CONTRACT NO. DE-AC27-01RV14136 – TRANSMITTAL OF U.S. DEPARTMENT OF ENERGY (DOE), OFFICE OF RIVER PROTECTION (ORP) DESIGN ASSESSMENT REPORT NUMBER D-07-DESIGN-048: DESIGN ASSESSMENT OF PRETREATMENT (PT) FACILITY PROCESS SYSTEMS IN THE CESIUM ION EXCHANGE PROCESS SYSTEM (CXP) AND CESIUM NITRIC ACID RECOVERY PROCESS SYSTEM (CNP) BLACK CELLS

WASTE TREATMENT AND IMMOBILIZATION PLANT (WTP) DESIGN ASSESSMENT OF PRETREATMENT FACILITY PROCESS SYSTEMS IN THE CESIUM ION EXCHANGE PROCESS SYSTEM (CXP) AND CESIUM NITRIC ACID RECOVERY PROCESS SYSTEM (CNP) BLACK CELLS

DESIGN OVERSIGHT: D-07-DESIGN-048

Figure 1. Block Flow Diagram for the Cesium Ion Exchange Process System

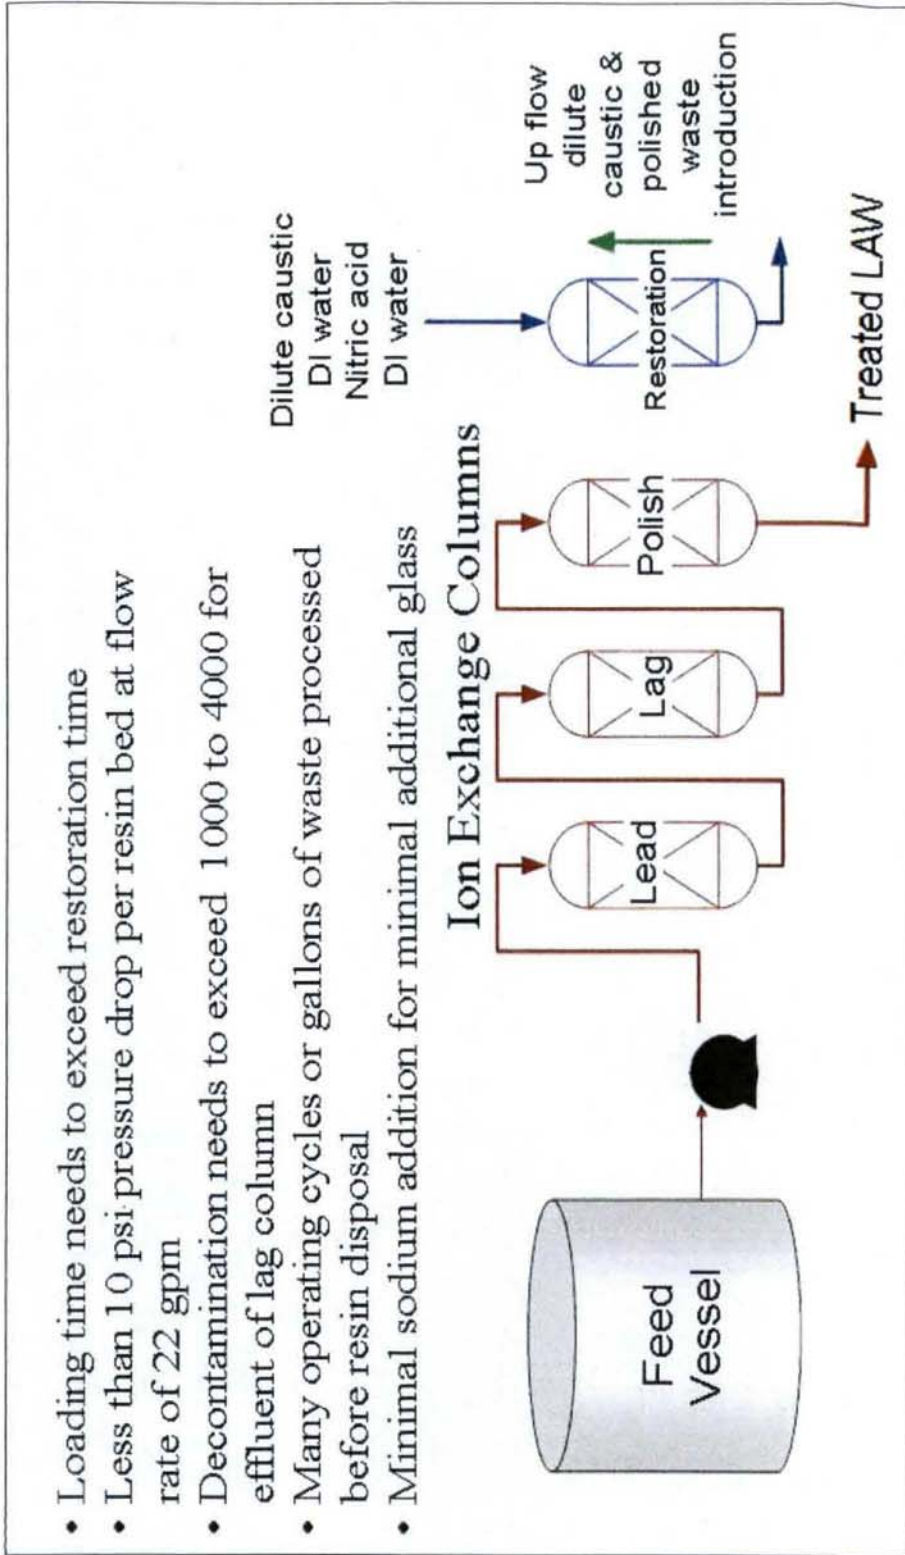
The CXP is described in 24590-PTF-3YD-CXP-00001, *System Description for the Cesium Ion Exchange Process - System CXP*. A block flow diagram of the CXP is provided in Figure 1. The primary functions of the CXP are to receive ultrafiltration permeate from the Ultrafiltration Process System (UFP), remove cesium from the UFP permeate using ion exchange (IX), transfer the cesium-treated low-activity waste (LAW) (e.g., eluate) to the Treated LAW Feed Evaporator System (TLP), and maintain hydrogen to a concentration below the lower flammability limit. UFP permeate solution is transferred from the three UFP permeate vessels to the cesium IX feed vessel (CXP-VSL-00001). Because the IX media (resin) has a limited capacity for cesium, the CXP requires an elution using dilute nitric acid and post-elution rinse to regenerate the resin media. This eluate is sent to the CNP evaporator where the nitric acid is recovered and the cesium and other salts are concentrated before transferring to the HLW Lag Storage and Feed Blending System (HLP).

There is potential precipitation in CXP-VSL-0001 as a consequence of the cooling of permeate passing through the ultrafiltration system. This accumulation of solids will require mixing components not currently in the CXP-VSL-0001 design. This issue was also identified as part of the PT TRA.

- The CXP IRP will evaluate the adequacy of the design concept for the Cesium Ion Exchange Vessel, CXP-VSL-00001. This vessel will be re-evaluated to determine a need for waste mixing, heating/cooling, and chemical addition capability based on recent

Figure 2. Block Flow Diagram for the Cesium Nitric Acid Recovery Process System

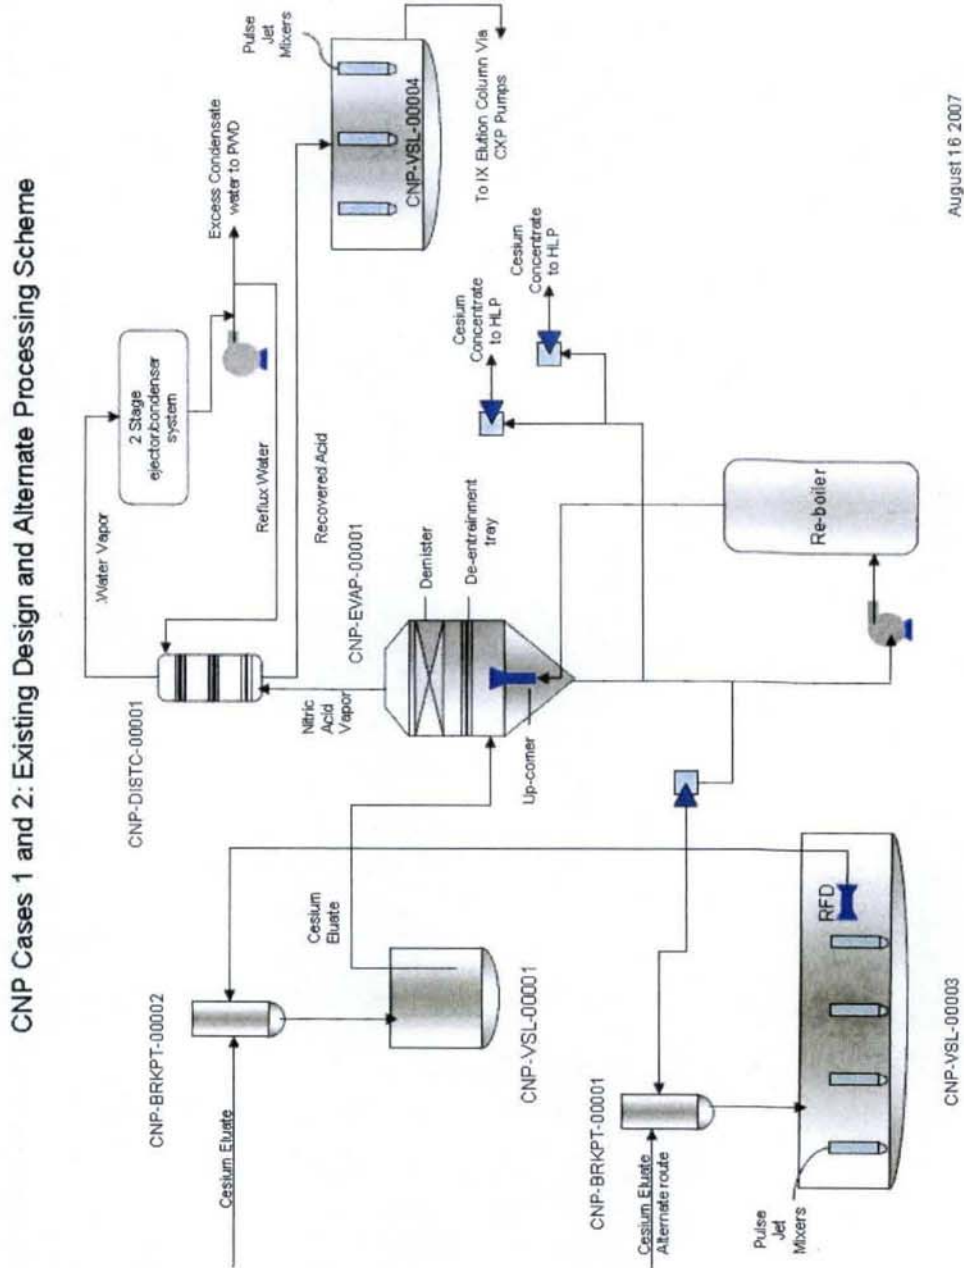
The CNP is described in 24590-PTF-3YD-CNP-00001, *System Description for the Pretreatment Facility Cs Nitric Acid Recovery Process (CNP) System*. A block flow diagram of the CNP is provided in Figure 2. The primary functions of the CNP are to receive eluate from the CXP; concentrate the eluate; transfer eluate concentrate to the HLP; and recover the evaporator overheads stream as nitric acid eluent for reuse in the CXP.

Cesium eluate and rinse water are sent from the CXP on a periodic basis to the cesium evaporator breakpot. The eluate received from the IX column is, on average, more dilute than the 0.5M nitric acid used for elution. In addition, the concentration of nitric acid will vary throughout the elution cycle starting with a more dilute concentration, reaching a maximum concentration, and ending with a more dilute concentration. This fluctuation raised a concern during this review.

The fluctuation occurs because hydrogen ions are exchanged with eluted cations (aluminum, calcium, cesium, potassium, sodium, etc.) on the IX resin during the elution process and because some wash water (used for displacing residual caustic and nitric acid from the IX column) will precede and follow the eluate transfers to the evaporator. The breakpot may also receive infrequent transfers of eluate or concentrate from the eluate contingency storage vessel that will also cause chemical fluctuations.

- Lack of prototypical demonstration of an integrated evaporator/rectifier system handling similar feed streams and producing similar products
- CNP operability and instrumentation functionality
- Control of solids precipitation within the evaporator
- Control of entrainment and foaming within the evaporator, and limitation of cesium carryover in recovered nitric acid eluant (system decontamination factor)
- Adequacy of materials of construction to support 40-year operating life
- Maintainability and access needed to support 40-year operating life
- Potential need for caustic neutralization of cesium concentrate prior to transfer to HLW feed

In order to resolve these issues, ORP and BNI are in the process of preparing an IRP. The IRP proposes to resolve the seven issues through equipment modifications or additions to be defined in a CNP closure report that reflects results of a detailed design review (including expert consultant input) and possibly also the results of bench-scale and/or prototypical system tests.

Issue resolution will be based on the use of well-known and established data for physical and thermal properties, vapor-liquid equilibrium, salt solubility, and corrosion rates for nitric acid solutions. Past experience from commercial-scale nitric acid evaporation and rectification operations, including evaporator decontamination factors, will be considered. Vendor input will be solicited. Operation of the current CNP design as an integrated system will be simulated by computer models, including evaluation of the several batch-continuous CXP elution cycles planned within each evaporation cycle. Control and monitoring instrument requirements to ensure steady operation during these cycles will be determined. Adequacy of equipment sizing, vessel surge volumes, entrainment separation, mixing, foam detection and control, salt precipitation control, concentrate transfer ejector system, etc. will be evaluated. Bench-scale and/or prototypical testing may be performed if necessary to resolve design or operability issues.
